Strand Lighting

Document : 7Z0046

M24 UPGRADES HANDBOOK

1.1 Tempus M24 Console Motherboard Ref. I832

Additional modifications to the M24 front panel.

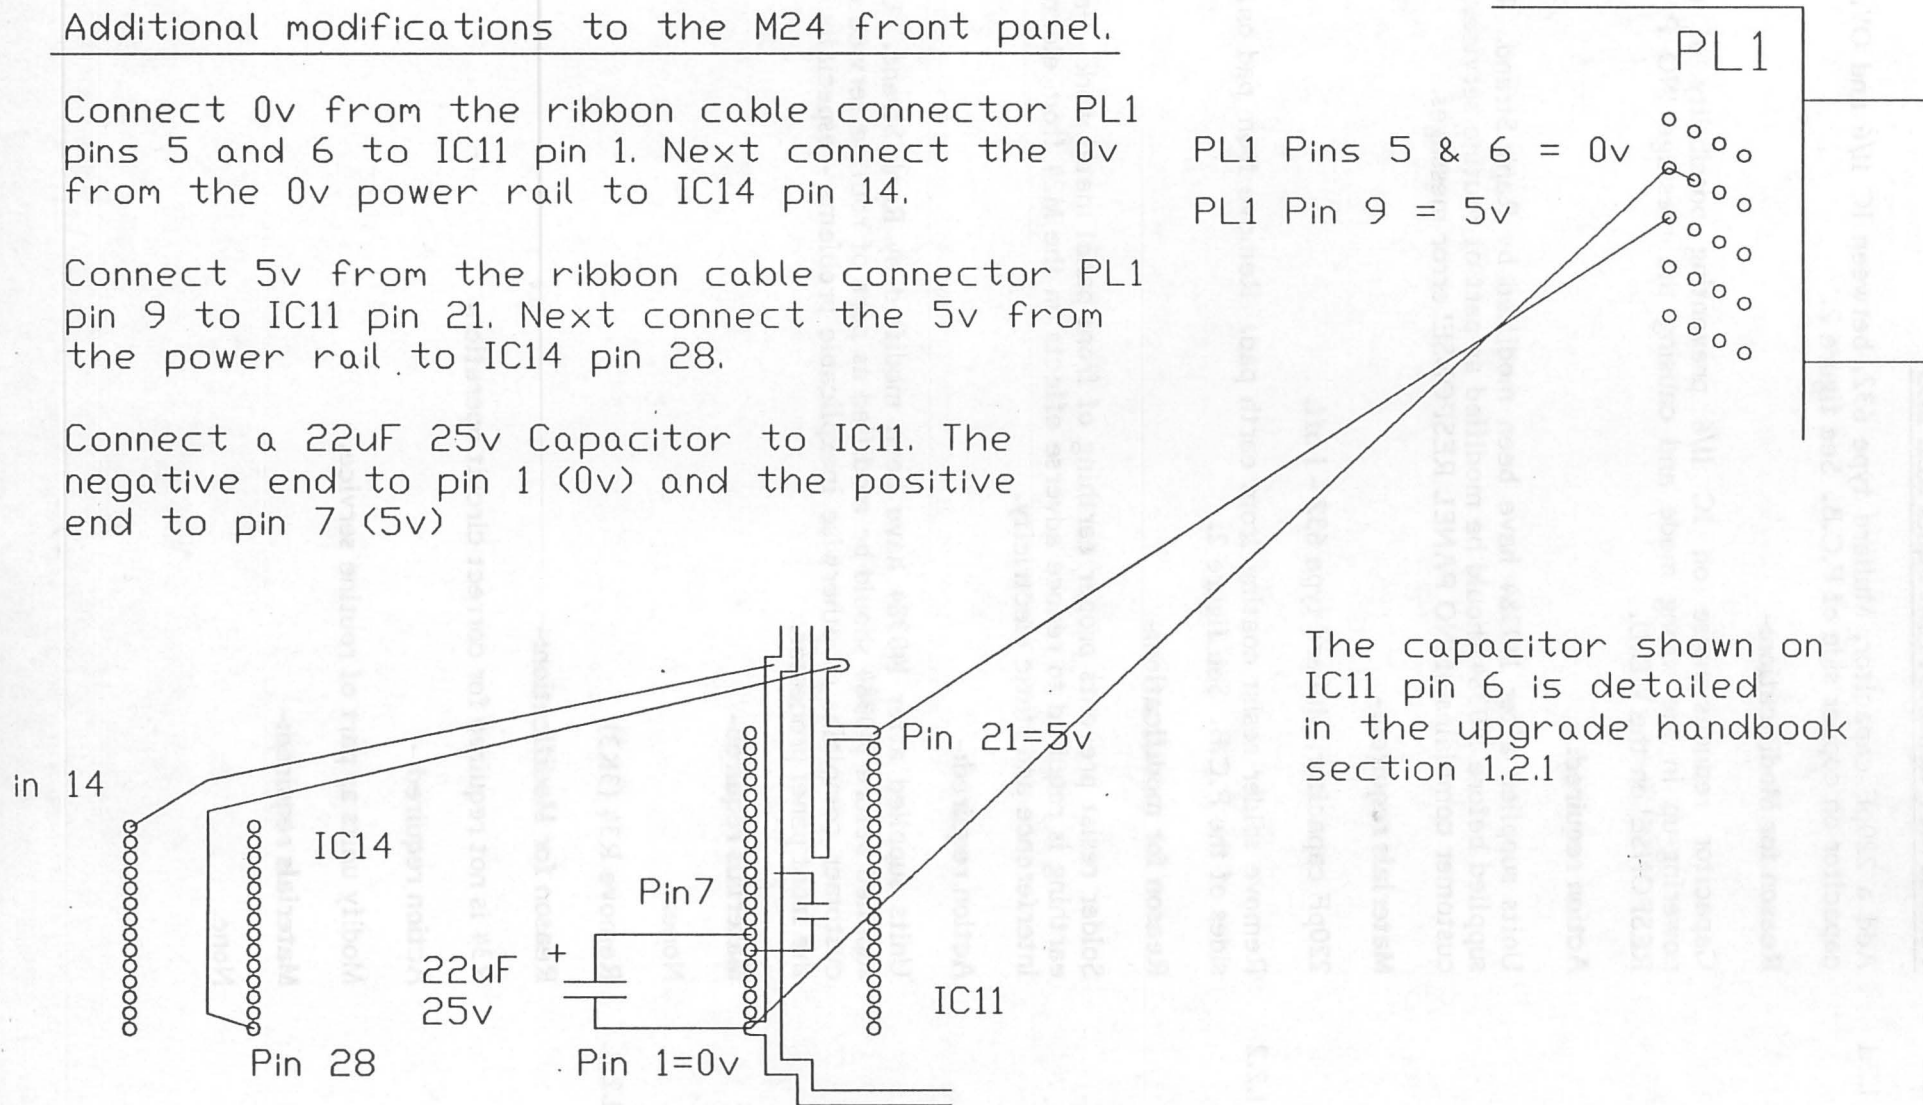
Connect 0v from the ribbon cable connector PL1 pins 5 and 6 to IC11 pin 1. Next connect the 0v from the 0v power rail to IC14 pin 14.

Connect 5v from the ribbon cable connector PL1 pin 9 to IC11 pin 21. Next connect the 5v from the power rail to IC14 pin 28.

Connect a 22uF 25v Capacitor to IC11. The negative end to pin 1 (0v) and the positive end to pin 7 (5v)

FIGURE 1

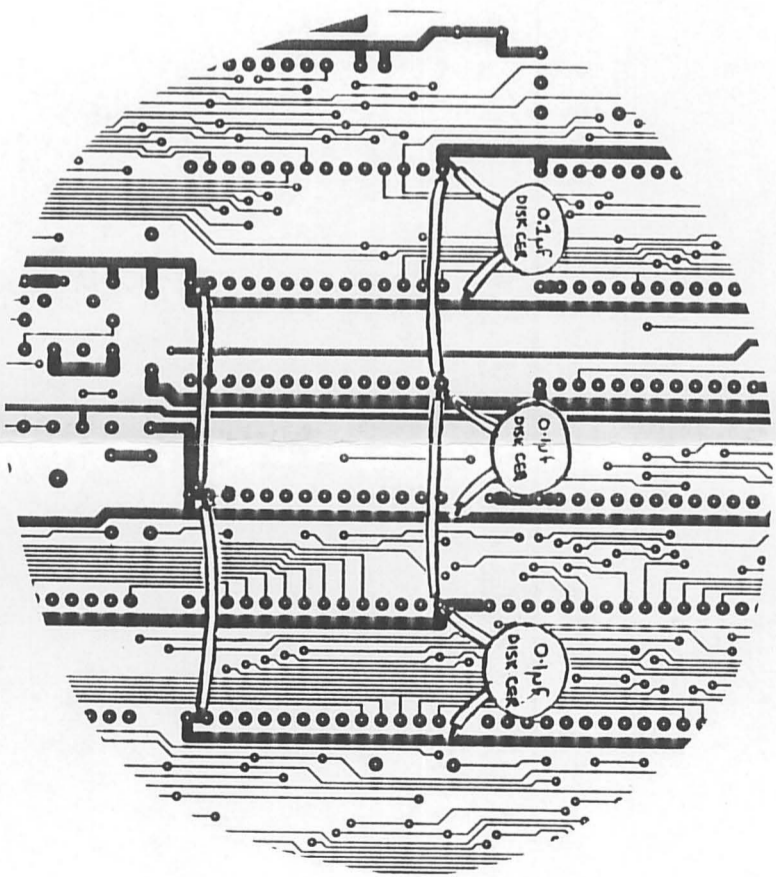
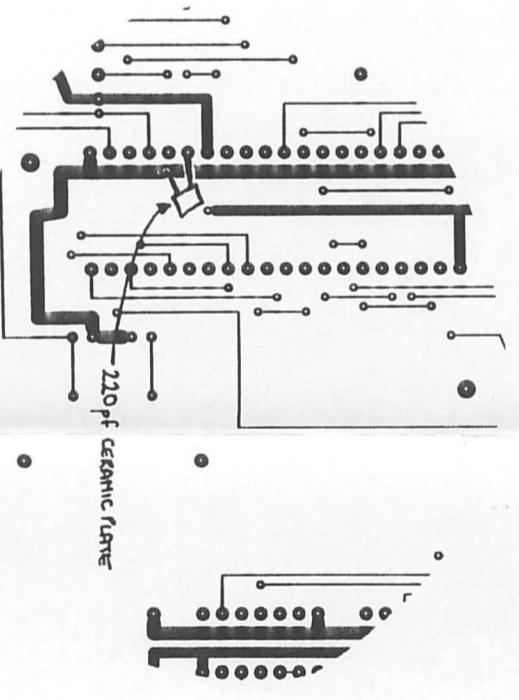
- 1.1.1 Using 0.5mm² PTFE insulated wire, link IC 22/14 to IC 25/14 to IC 29/14, link IC 22/28 to IC 25/28 to IC 29/28.

Add a 0.1 F 50V disc ceramic capacitor between pins 14 and 28 on each of IC's 22, 25, 29. Attach the capacitors on the copper side of the P.C.B. and make the leads as short as possible.

The instantaneous power demand of PROM's IC's 22, 25, 29 can generate severe noise spikes on the 0V and +5V power rails causing incorrect microprocessor action, and system failure. The addition of the wire links and capacitors reduces the power rail impedance.

FIGURE 2

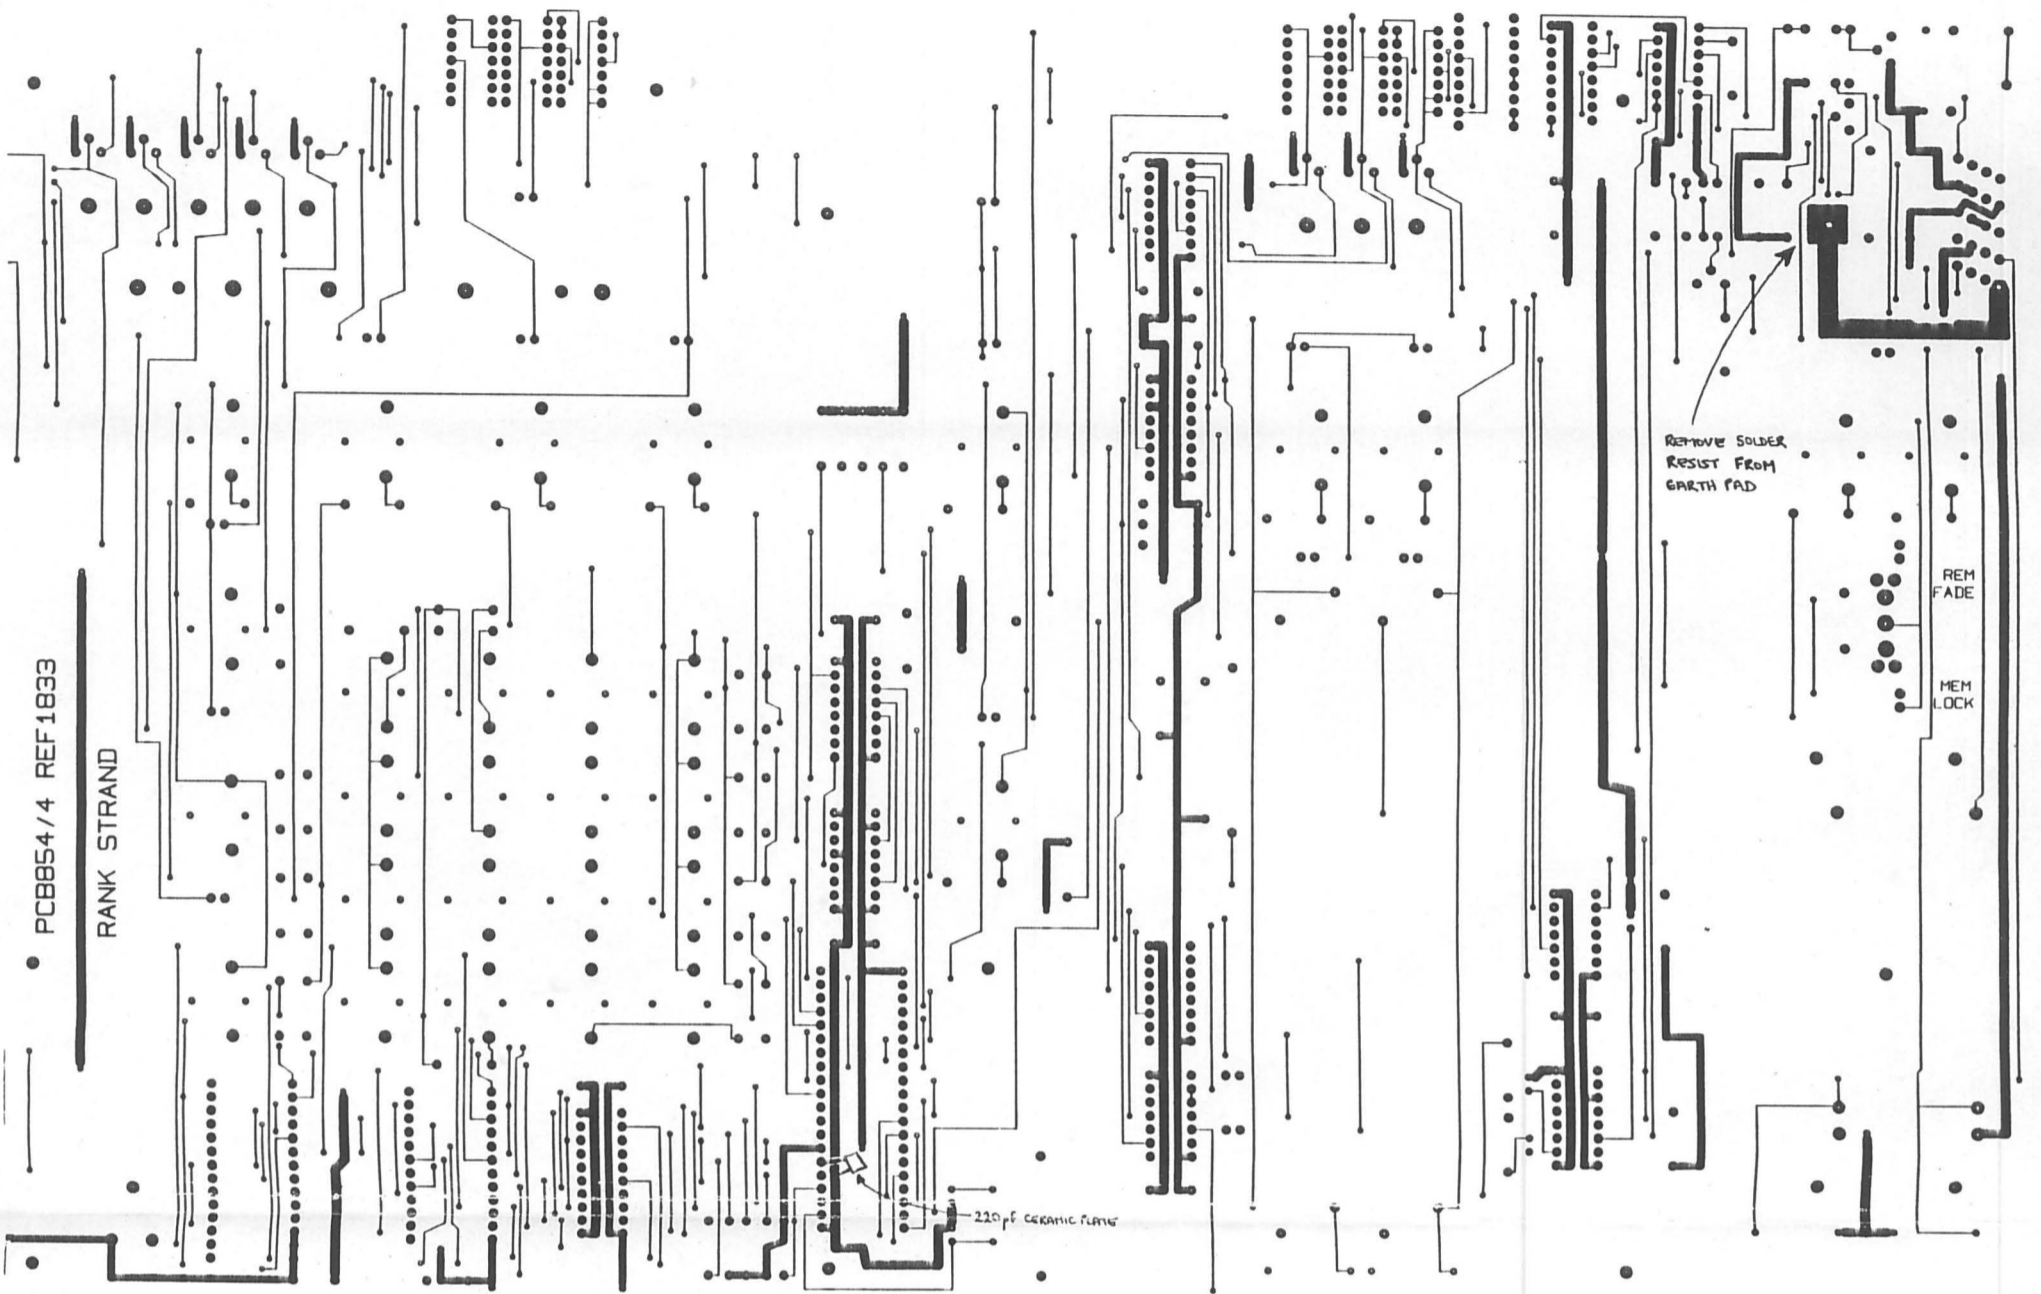
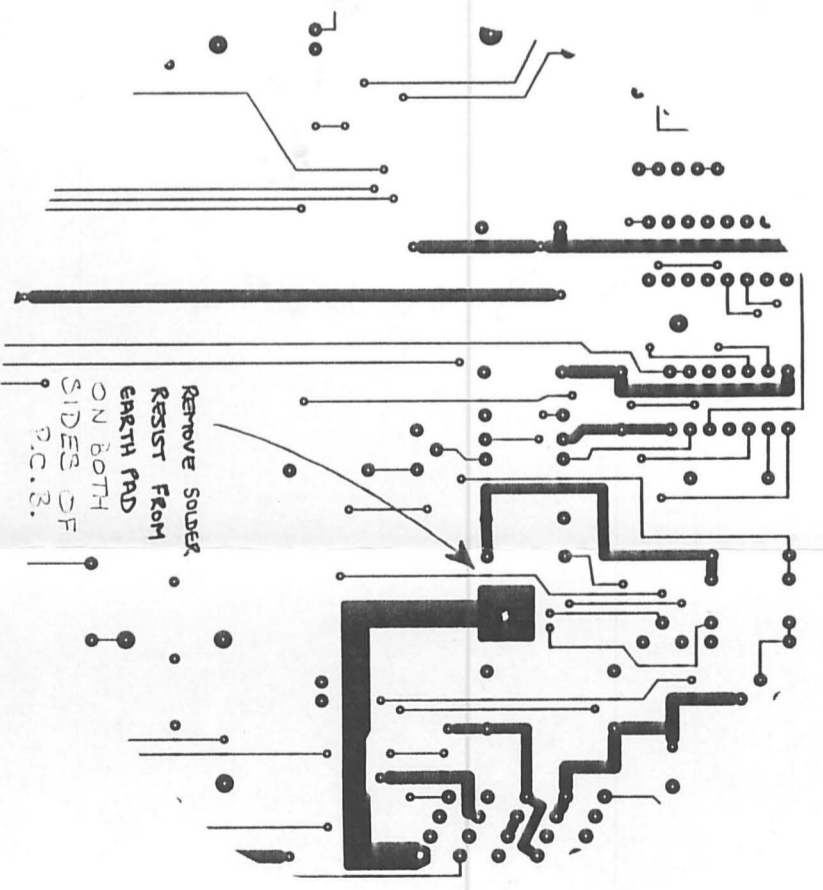
- 1.2.1 Add a 220pF capacitor, Mullard type 632, between IC 11/6 and OV. Fit capacitor on copper side of P.C.B. See figure 2.

Capacitor reduces noise on IC 11/6 preventing possibility of panel powering-up in the wrong mode and causing the message 'NO PANEL RESPONSE' on the V.D.U.

- 1.2.2 Remove solder resist coating from earth pad. Remove from pad on both sides of the P.C.B. See figure 2.

Solder resist prevents proper earthing of front panel metal work. Proper earthing is required to reduce adverse effects on the M24 from electrical interference and static electricity.

DETAILS OF MODIFICATION I.S.I.

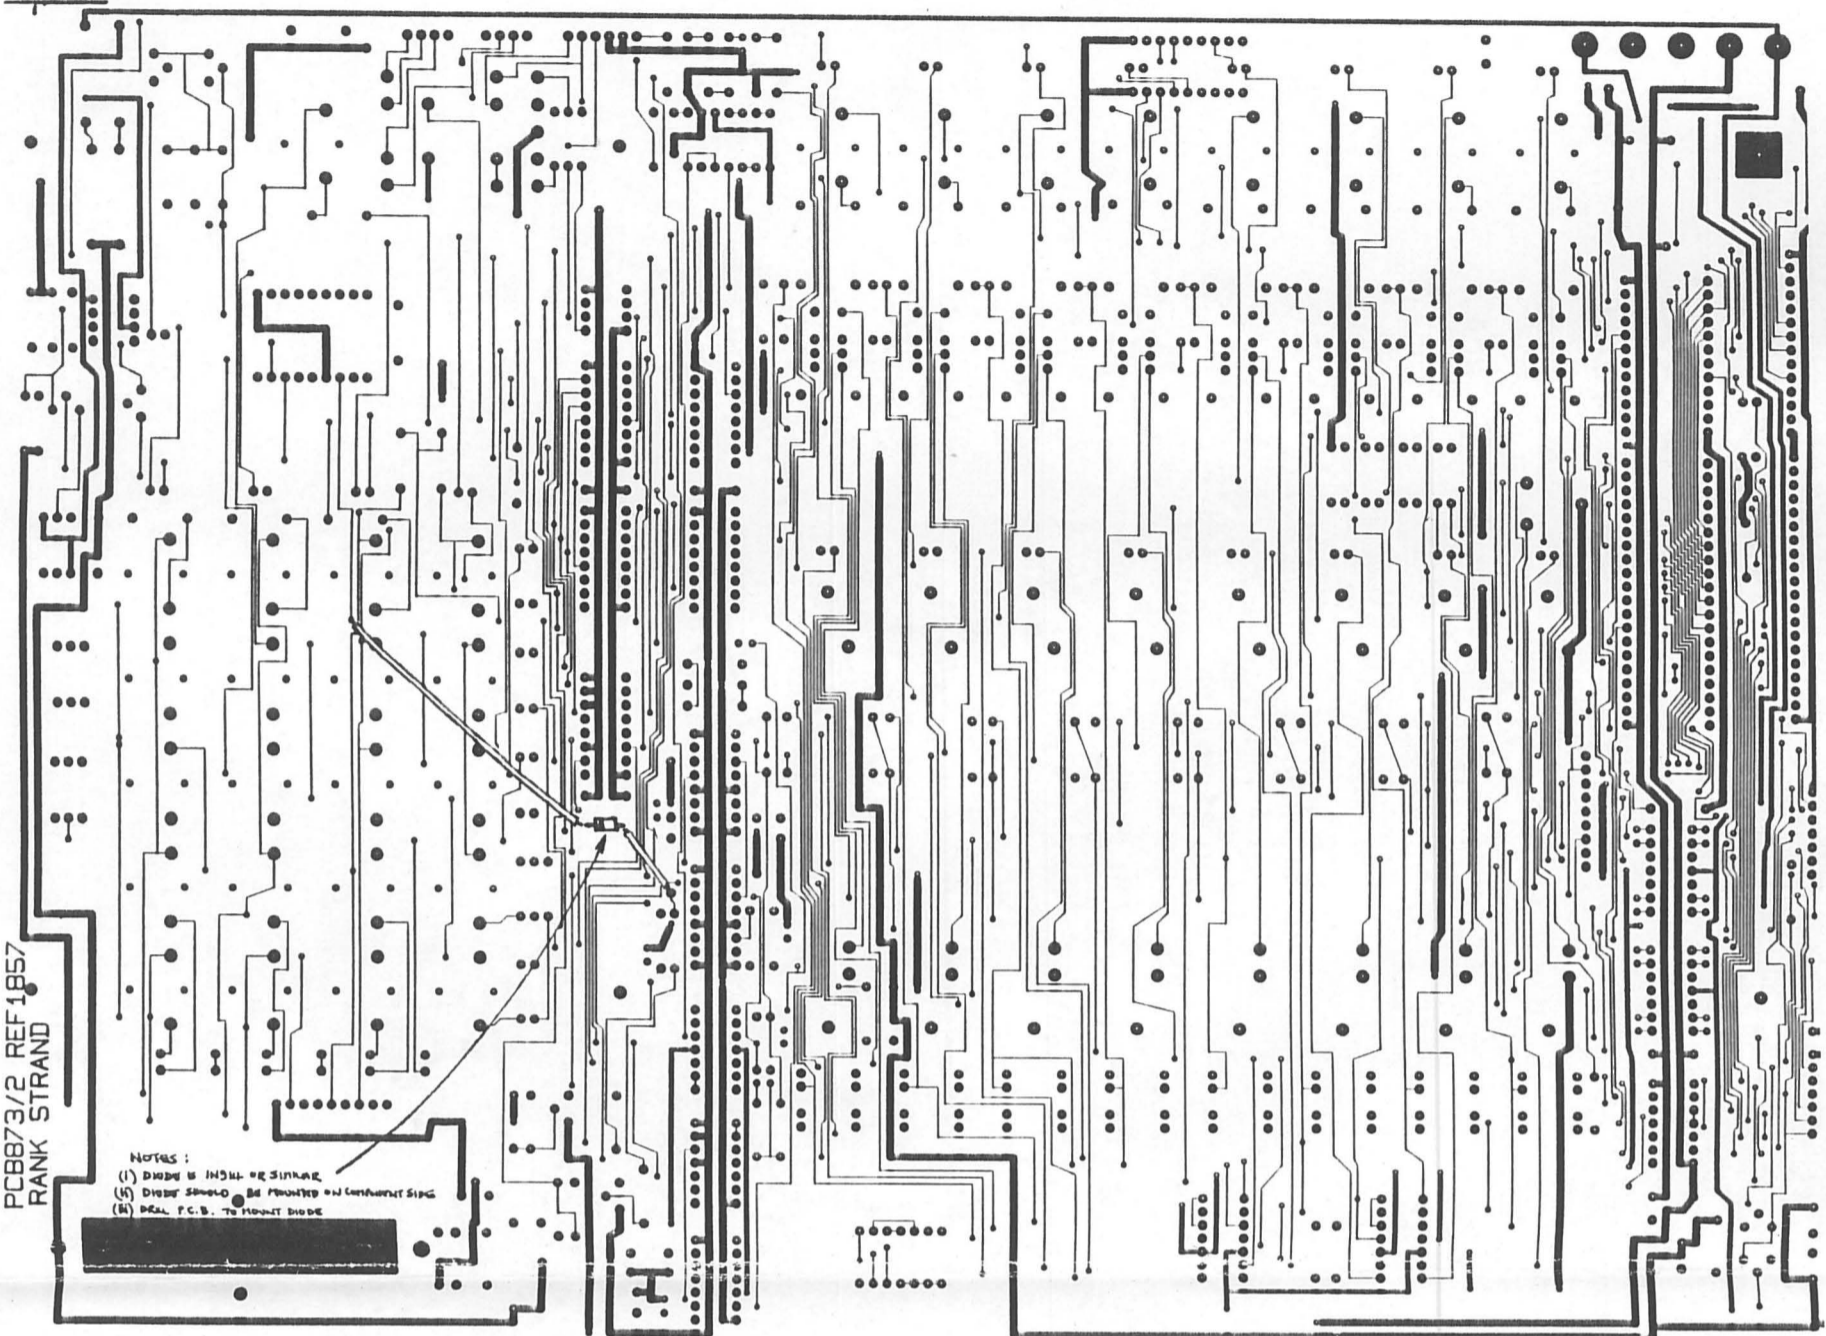
- 1.5.1 Add 1N914 diode between the junction of R84 and D2, and 'Reset' (DIS 1/3). The cathode of the diode must connect to DIS 1/3. The diode should be mounted on the component side of the P.C.B. by drilling two holes in the P.C.B. Wire links should then be used to connect the diode into the circuit.

The modification ensures that an oscillator formed by IC27 and IC28 starts running when the unit is switched on.
